FIRE STATION NO. 10 MODIFICATIONS

TITLE: FIRE STATION NO. 10 MODIFICATIONS
ARCHITECTURAL FLOOR PLAN AND DETAILS

RELIANCE STEEL COMPANY
1801 EIGHTH STREET NW.
ALBUQUERQUE, NM 87102

ONE-FRAME F3
(3/S2)

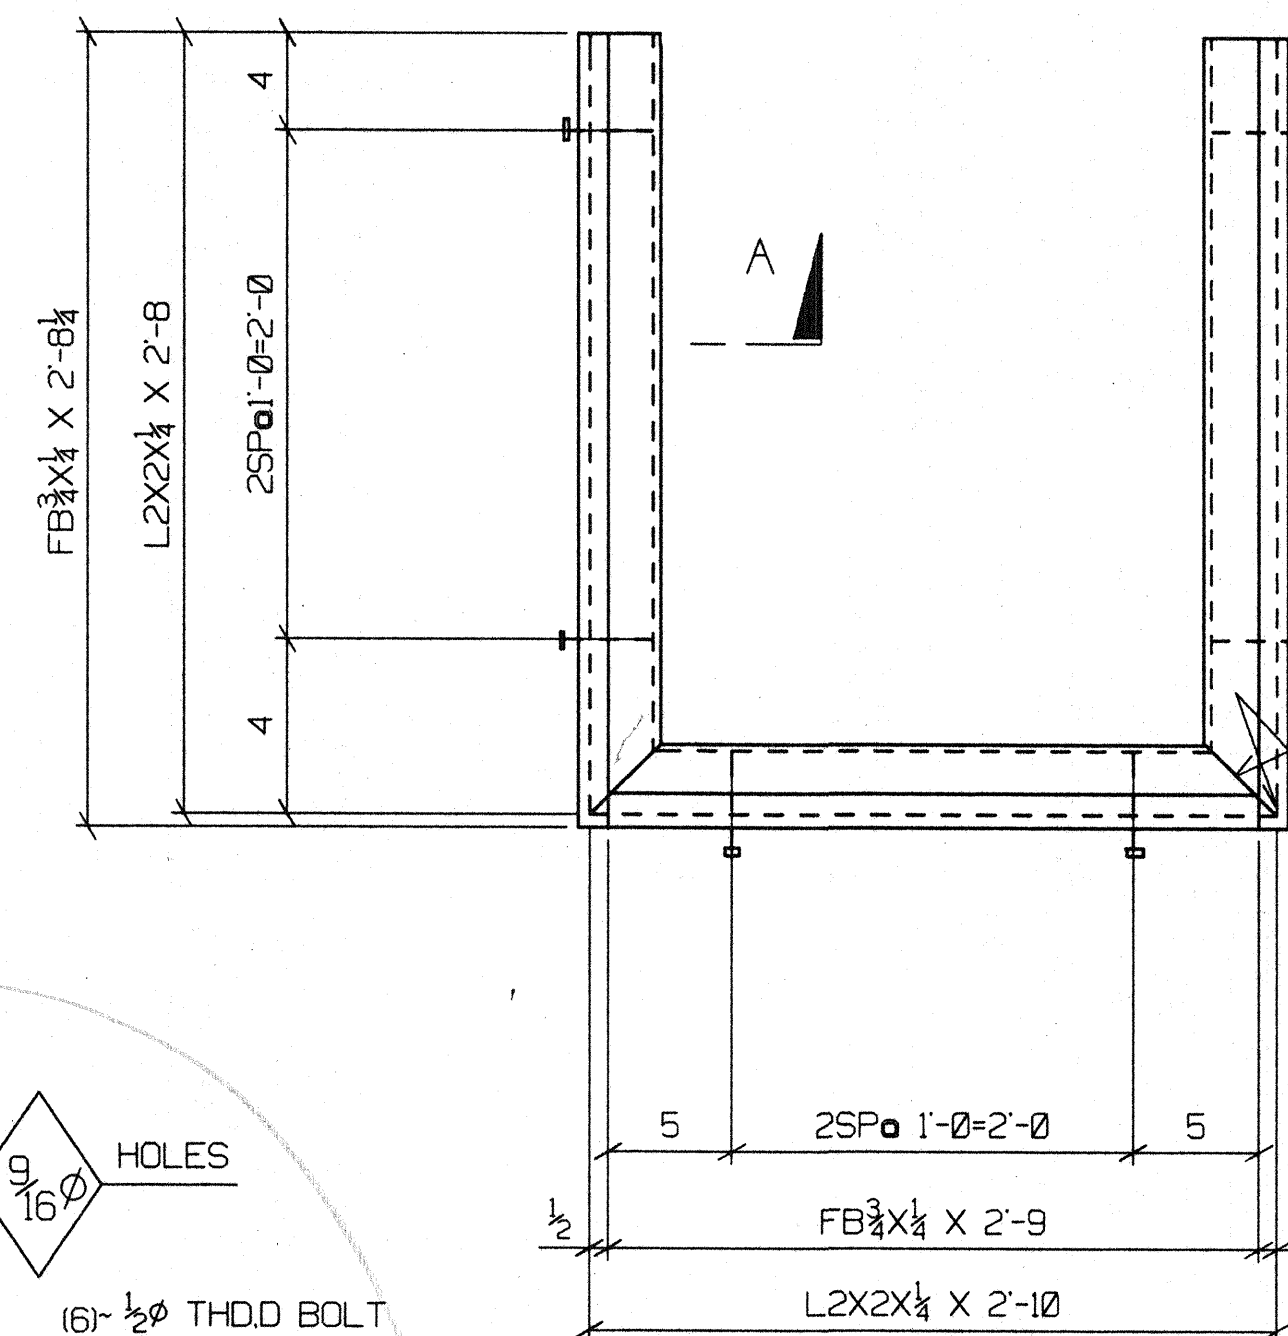
SHOP DRAWING REVIEW

A. NO EXCEPTIONS TAKEN
B. NO EXCEPTIONS TAKEN
SUBJECT TO CORRECTIONS NOTED
C. REVISE & RESUBMIT
D. REJECT - RESUBMIT
